UNITED STATES PATENT AND TRADEMARK OFFICE

APPLICATION NO.	FILING DATE	FIRST NAMED INVENTOR	ATTORNEY DOCKET NO.	CONFIRMATION NO.
10/500,904	02/11/2005	Philippe Vincent	12400-015	1396
757 7590 07/20/2007 BRINKS HOFER GILSON & LIONE P.O. BOX 10395 CHICAGO, IL 60610			EXAMINER CULBRETH, ERIC D	
			ART UNIT 3616	PAPER NUMBER
			MAIL DATE 07/20/2007	DELIVERY MODE PAPER

Office Action Summary	Application No.	Applicant(s)	
	10/500,904	VINCENT ET AL.	
	Examiner	Art Unit	
	Eric Culbreth	3616

DETAILED ACTION

FIG. 2

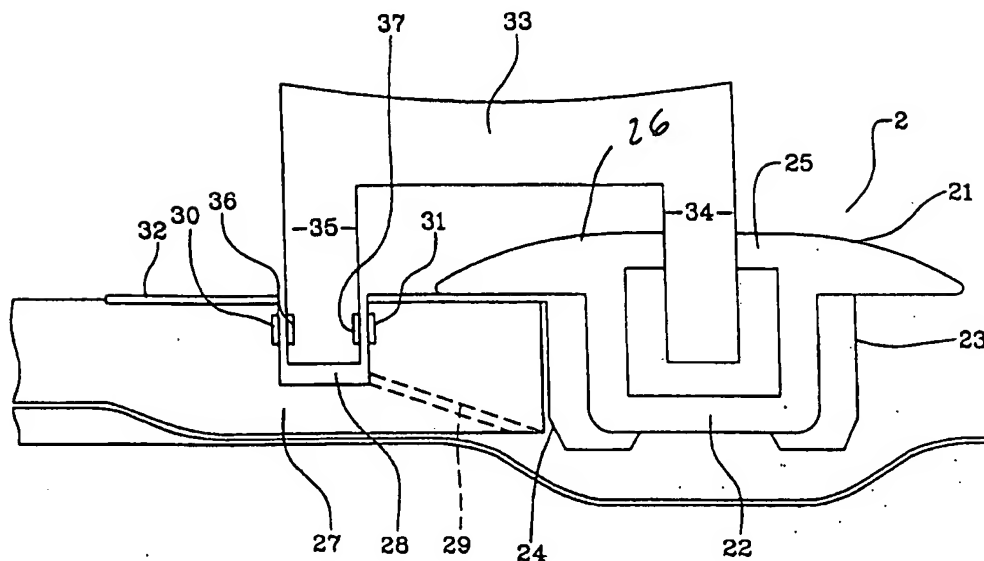
a. Regarding Figure 2, the lead line for reference numeral 2 should touch the track or have an arrow (note paragraph [0037]).

b. Contrary to paragraph [0037], line 4 the lead line for reference numeral 26 in the replacement drawing does not touch an inwardly directed lip.

FIG. 3

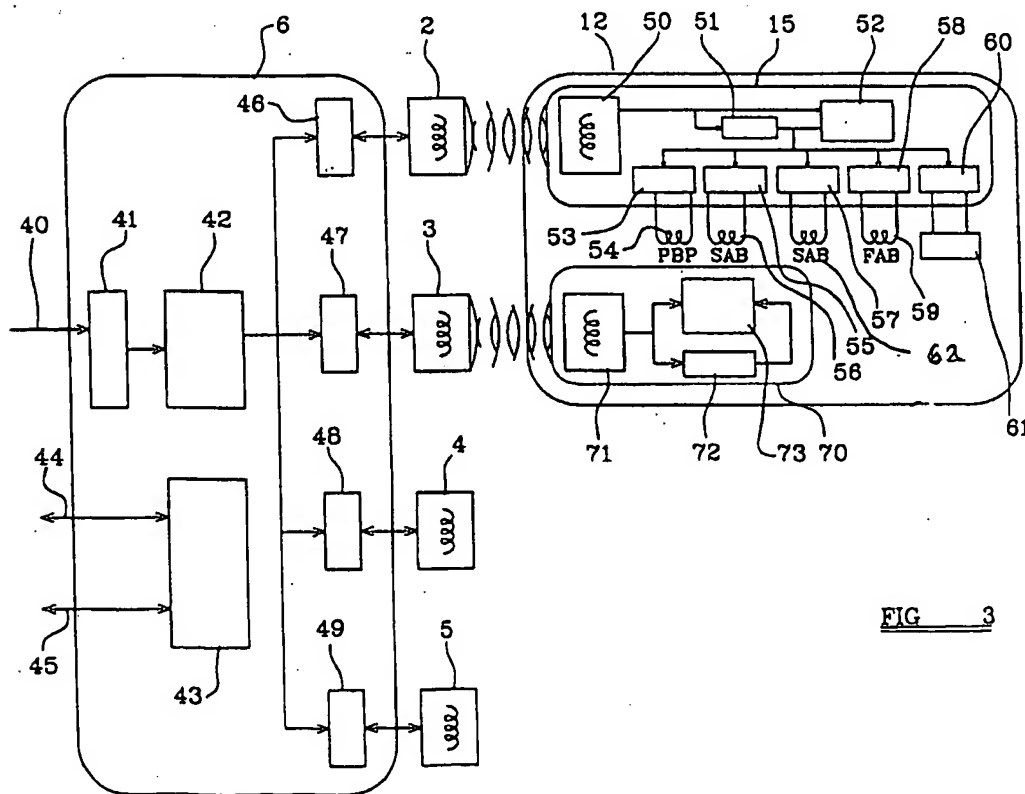
c. Regarding paragraph [0043], lines 4-5 controller 42 is not illustrated as connected to inter-face 43 in Figure 3.
